SHINE Medical Technologies, Inc. Preliminary Safety Analysis Report Revisions  
Resulting from Request for Additional Information Responses

#### **SHINE MEDICAL TECHNOLOGIES, INC. PRELIMINARY SAFETY ANALYSIS REPORT REVISIONS RESULTING FROM REQUEST FOR ADDITIONAL INFORMATION RESPONSES**

##### **REVISION 1 OF THE SHINE RESPONSE TO RAI 4B-2 AND RAI 11.1-6**

**PRELIMINARY SAFETY ANALYSIS REPORT CHANGES  
(MARK-UP)**

Figure 11.1-3 – Locations of Environmental Monitors

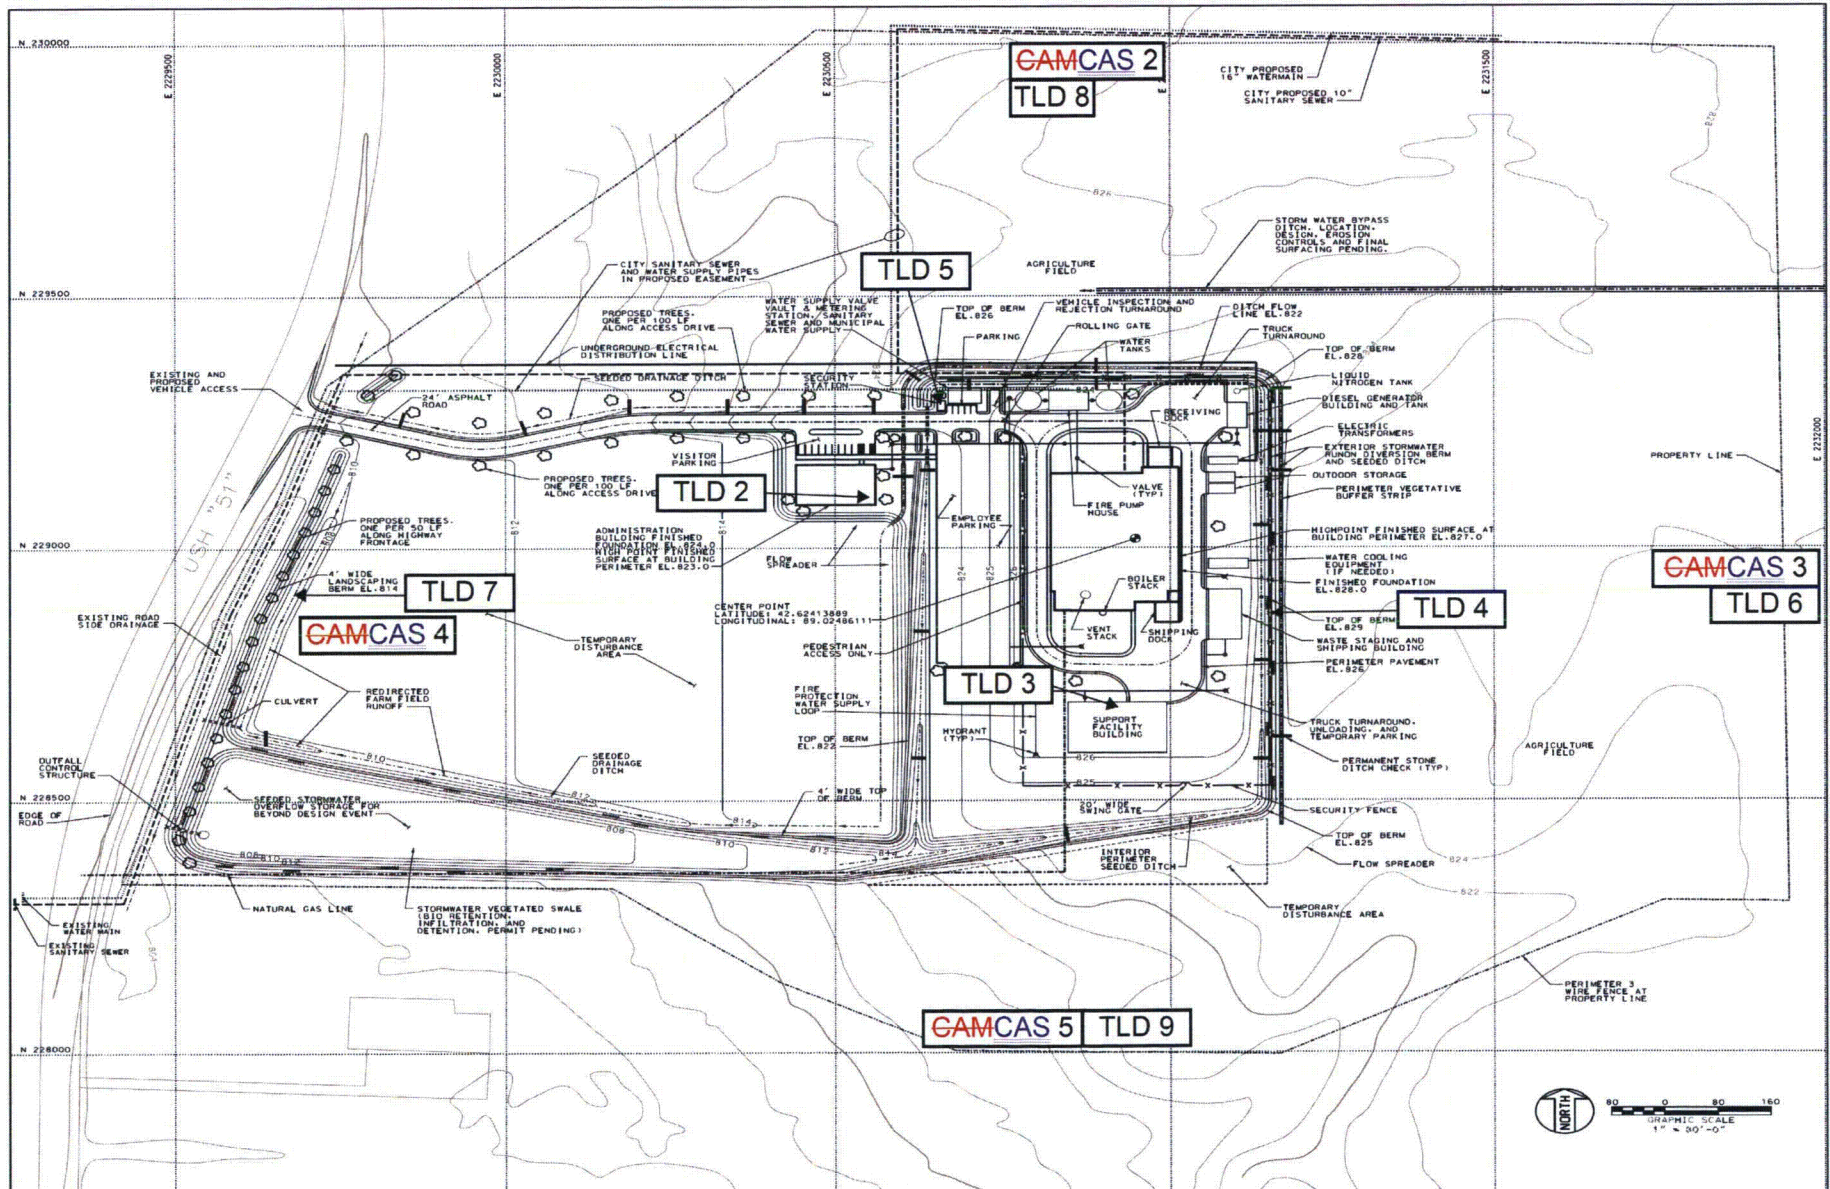
*SHINE PSAR, Section 11.1.7.2.2.1, "Air Sampling Locations," discusses the proposed air monitoring program. When discussing the equipment that will be used for air sampling, the applicant uses the term CAM (continuous air monitor). The conventional use of the term "continuous air monitor" denotes equipment that both samples and quantifies the activity on the sample media (i.e., real-time monitoring). Normally, CAMs are not used for such purposes and the NRC guidance document, NUREG-1301, "Offsite Dose Calculation Manual Guidance: Standard Radiological Effluent Controls for Pressurized Water Reactors," that the applicant cites, does not specify CAMs for environmental air sampling.*

*Clarify whether the term "air monitoring" is intended to refer to sample collection followed by laboratory analysis or real-time air monitoring.*

SHINE inappropriately used the term "CAM" to refer to a continuous air sampler in Subsection 11.1.7.2.2.1 of the PSAR. SHINE will employ continuous air samplers at the stated locations, with the samples collected and analyzed in a laboratory. SHINE has revised Subsection 11.1.7.2.2.1, Table 11.1-8, and Figure 11.1-3 to correct the terminology. A mark-up of the PSAR changes is provided in Attachment 1. The non-public (proprietary) version of the PSAR, incorporating the changes provided in Attachment 1, is provided in Enclosure 4. The public (non-proprietary) version of the PSAR, incorporating the changes provided in Attachment 1, is provided in Enclosure 5.

Four CAMCAS locations are near the facility property line in the north, south, east, and west direction sectors to ensure all directions are monitored. The north and east direction sectors (with respect to the SHINE facility vent stack) have the highest calculated annual ground level deposition factor (D/Q) values. There is also a CAMCAS located a sufficient distance from the SHINE facility to provide background information for airborne activity. Table 3.12-1 of NUREG-1301 suggests an additional CAMCAS location in the vicinity of a community having the highest calculated annual average ground-level D/Q. This CAMCAS requirement is combined with the CAMCAS located at the site boundary in the north direction (refer to Table 11.1-8). A description of air sample locations and the rationale for air sample locations are provided in Table 11.1-8. CAMCAS locations are shown on Figure 11.1-3.
